Technical Bulletin

Re: SmartFasten™ (tank-to-bowl connection) Kits – Clarification of Tightening Feature

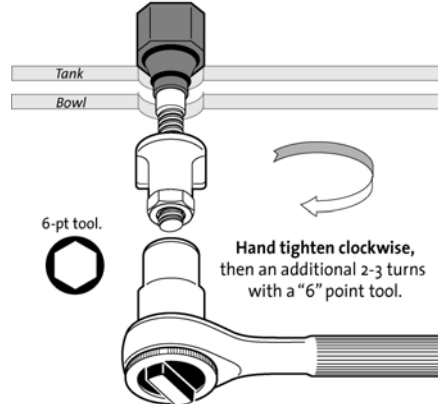
It had been stated that the polymeric wing nuts only needed to be hand tightened to properly install a tank to a bowl. Although installing the product in this manner makes for a water tight connection, the tank is **NOT** connected firmly enough to the bowl to satisfy most installers.

Nuts should be tightened to approximately 25 inch lbs. or 2 to 3 turns past hand tightened. This requires the use of a **“6” point 7/16” tool, preferably a 6 point socket as illustrated.** To prevent over tightening, the corners on the hex nut are designed to round over at 45 inch lbs. of torque.

All future SmartFasten™ packages will include this illustration:
